PROJECT: Epic Storage at Ann Road

CITY OF LAS VEGAS INTER-OFFICE MEMORANDUM			DATE: November 10, 2020
TO: Land Development Services Department of Building & Safety			FROM: Jennifer Shinn, P.E.  Flood Control, Engr. Associate Department of Public Works
SUBJECT:	Drainage Study for:		COPIES TO:
	Epic Storage at Ann Road		Horrocks Engineers
Cross Streets:	W Hammer Ln and N Shaumber Rd		Epic Development LLC
File Number:	F:\Depot\DSMemos\DS05314.doc		Bart Anderson, P.E., DevCo
Parcel Number:	126-36-101-017		CCPW CCRFCD
Zoning Action:	SDR-78449		
FEMA Flood Zone	YES	NO X	
Proposed Storm Drain	YES X	NO

ADDENDUM #1
TO THE
TECHNICAL DRAINAGE STUDY
FOR
EPIC STORAGE AT ANN ROAD
(APN 126-36-101-017)
IN
CITY OF LAS VEGAS, NEVADA

HORROCKS PROJECT NV-2108-1911

C.6.0

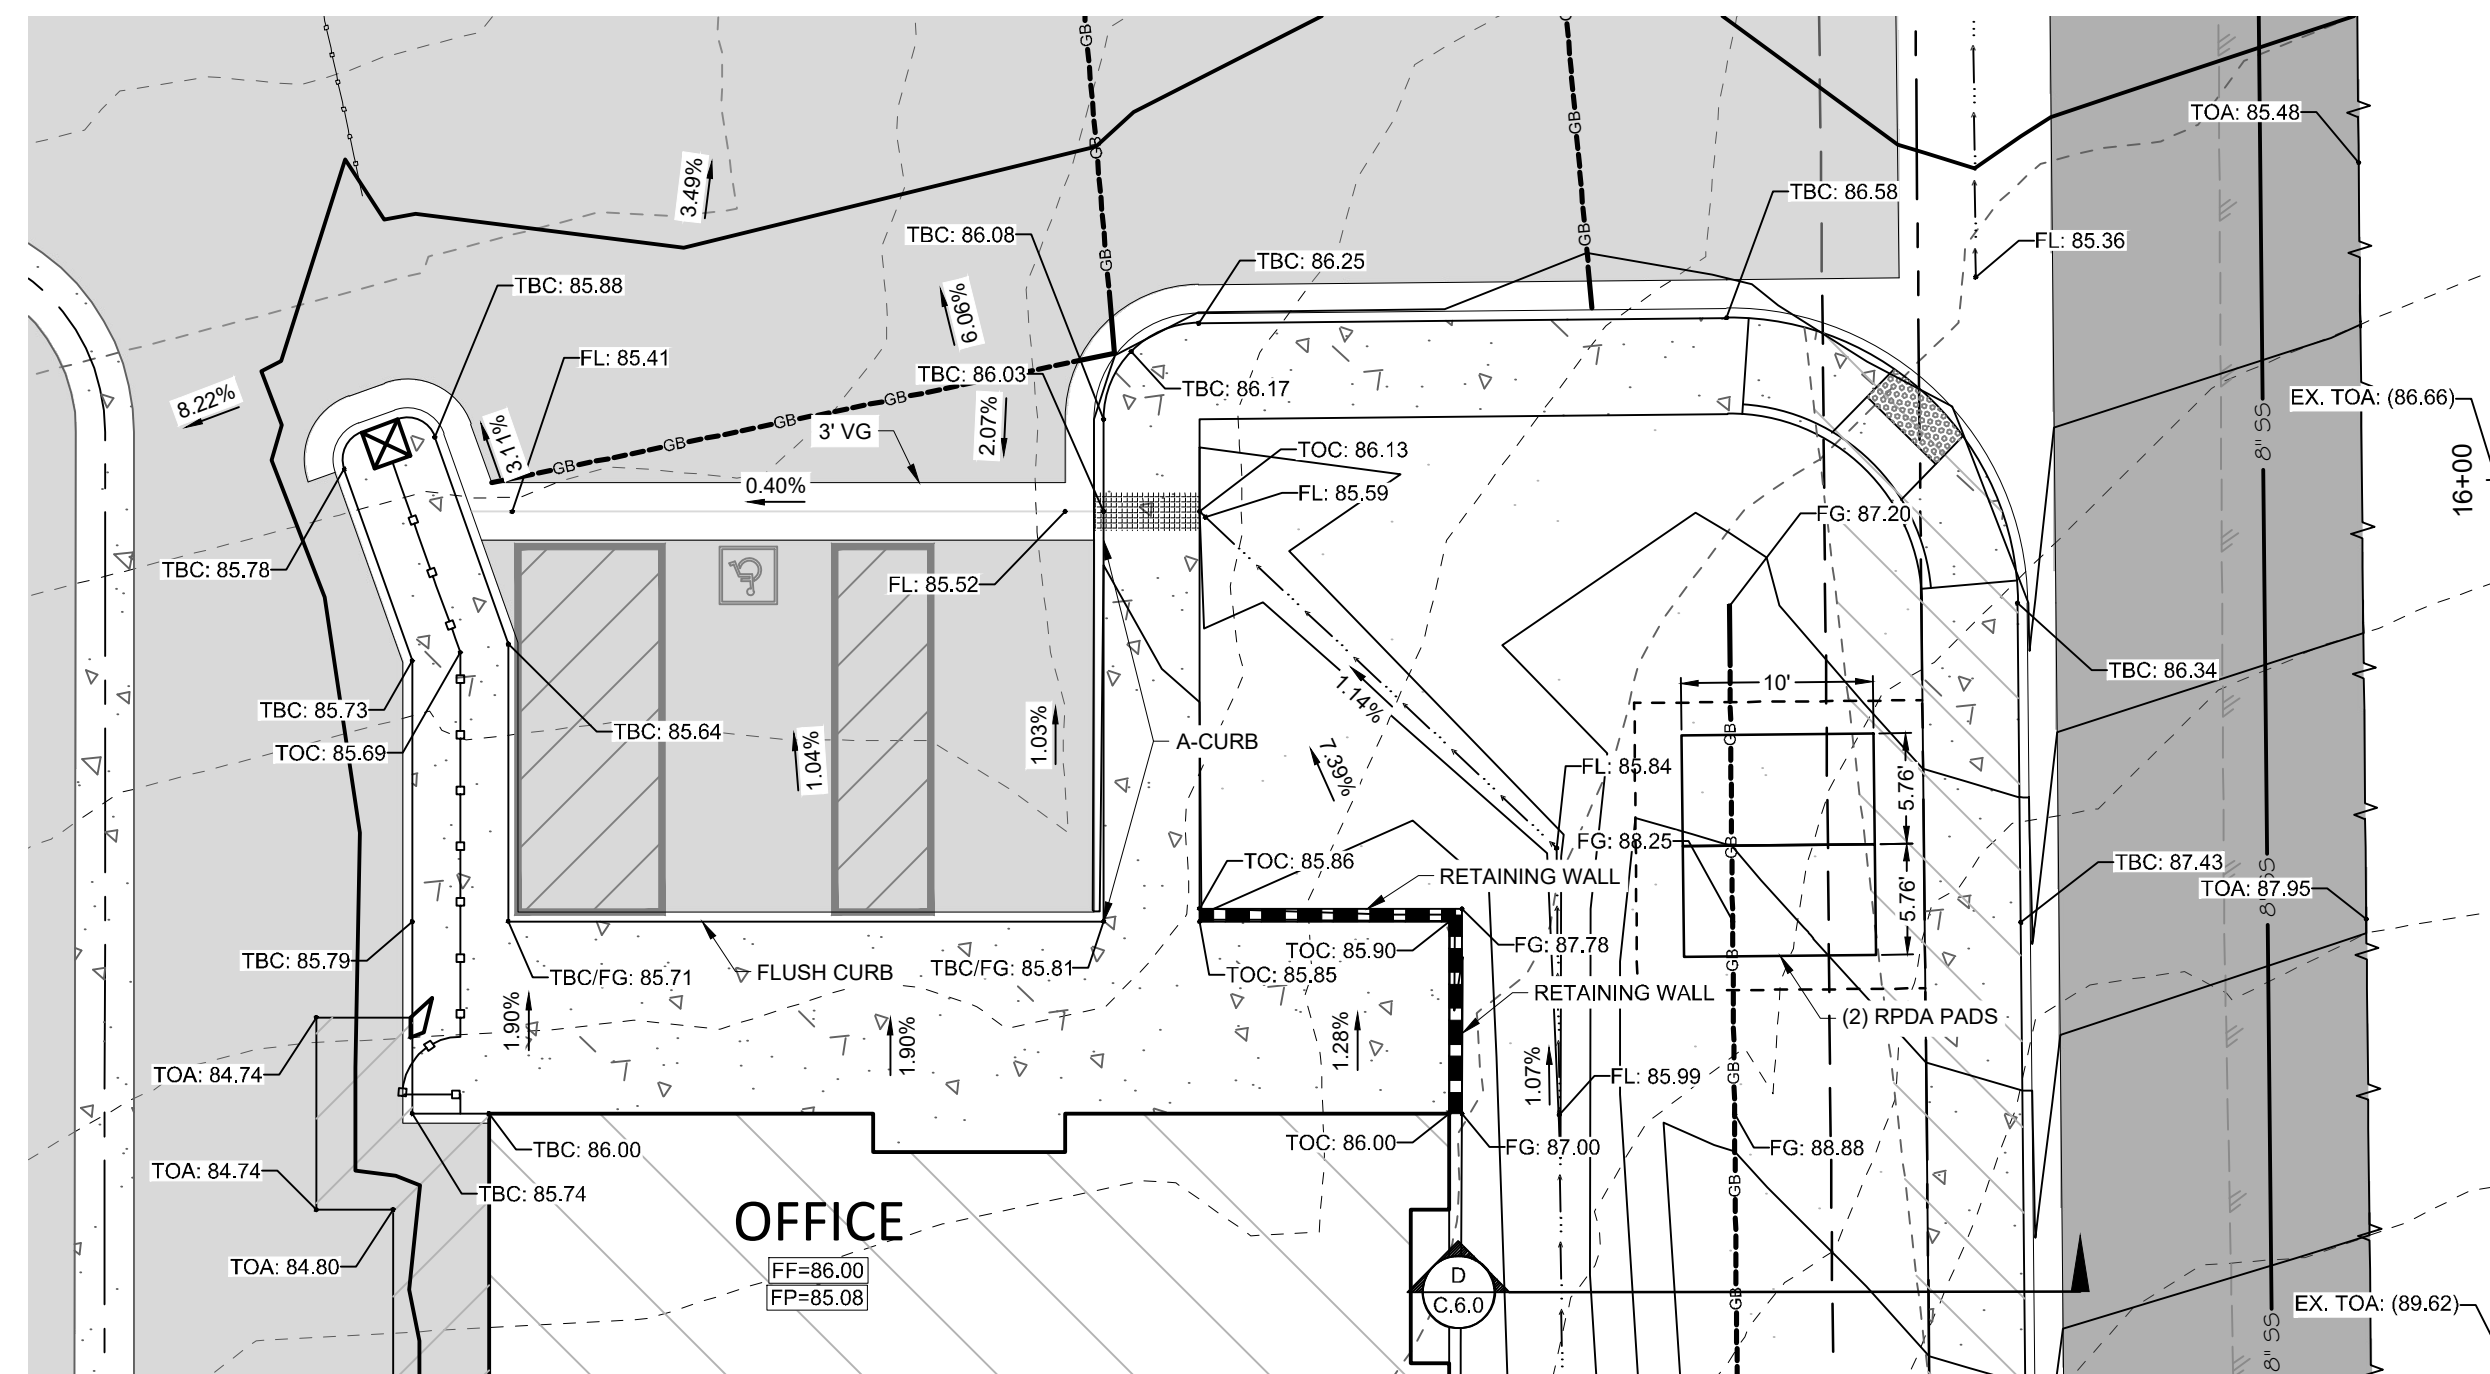
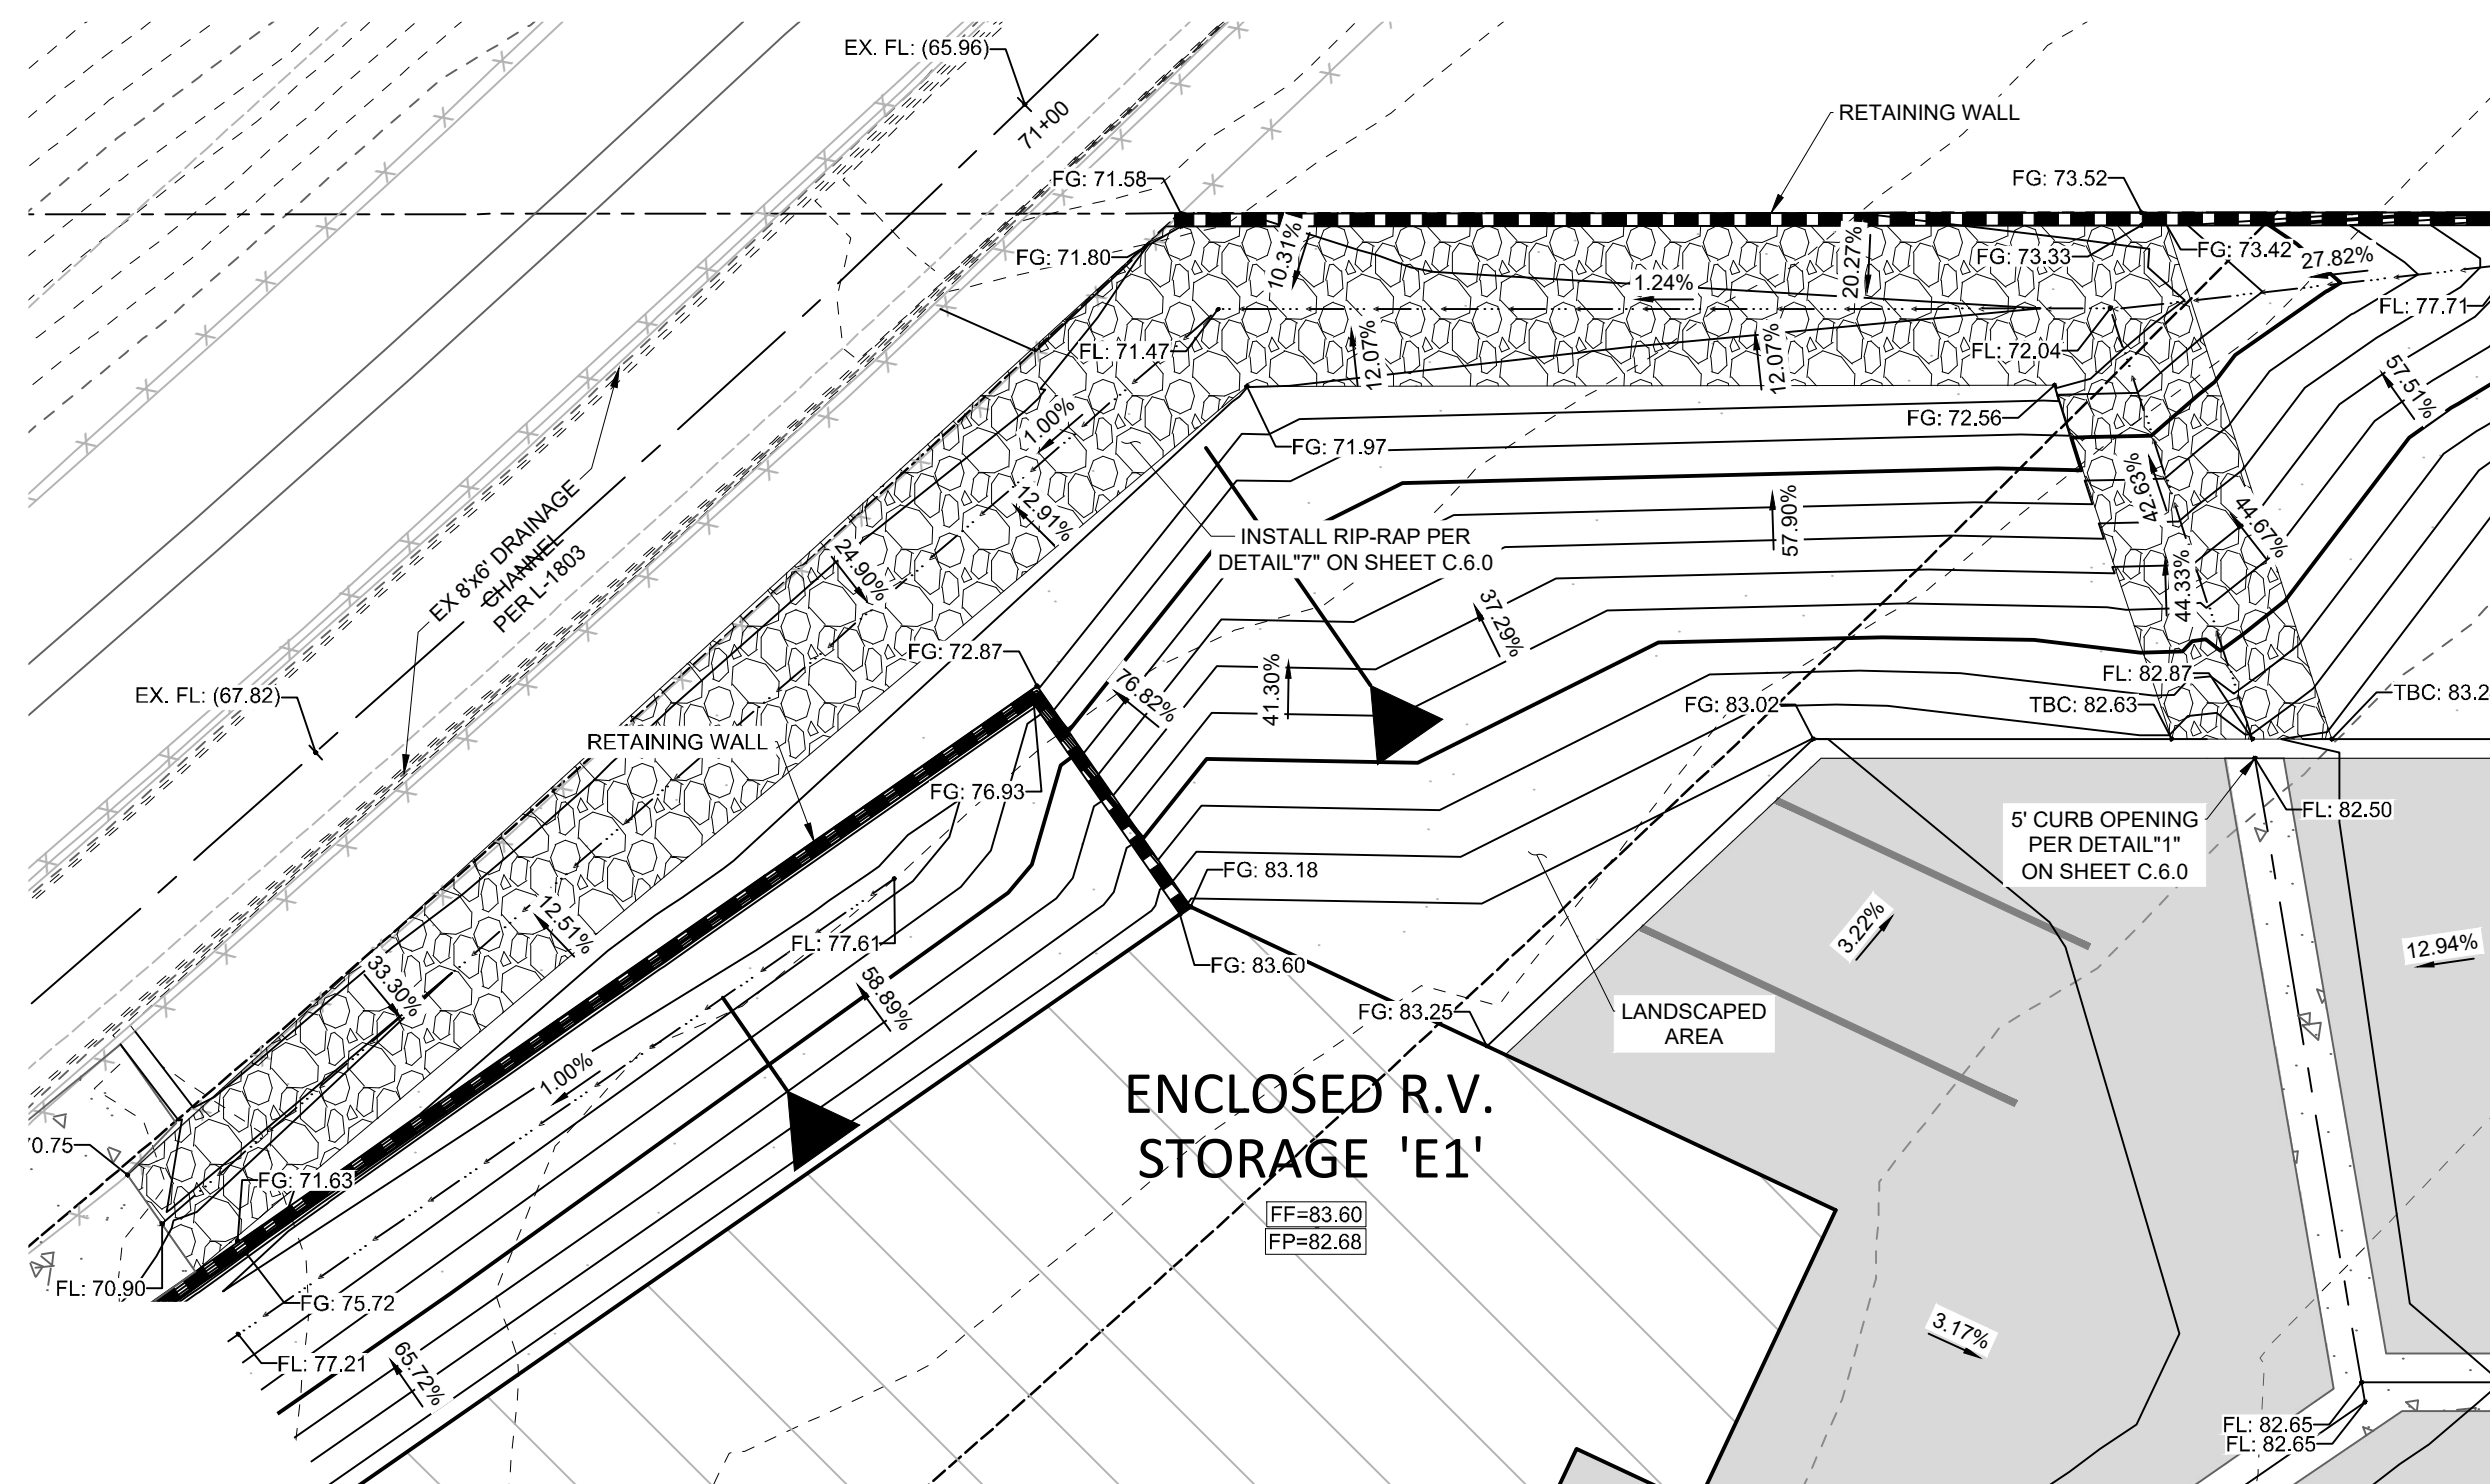
13. C.6.0 and C.6.1 show the Office building with a FF of 85.98 and 86.00, address this discrepancy.

15. Sections N and J on sheets C.2.0 and C.6.0 require 3 course solid grouted wall above the flow line on top of the retaining wall to protect the building from offsite flow. Revise the note for all sections showing solid grouting for flood control to indicate "8-inch minimum solid grouted CMU block XX courses above finish grade with all joints mortared," where XX is 18-inches or twice the depth above the calculated water surface elevation.

RESPONSE: The finish floor elevation on the plans now agree on all sheets.

RESPONSE: Section N and J have been revised to show the solid grouted note requested where CMU walls are located. However, the buildings require additional waterproofing above the top of the CMU wall elevations. For these areas, additional waterproofing of the walls has been called out. The buildings are protected to at least 24" (equivalent to 3 courses) above the flowline of the flow in the adjacent swale.
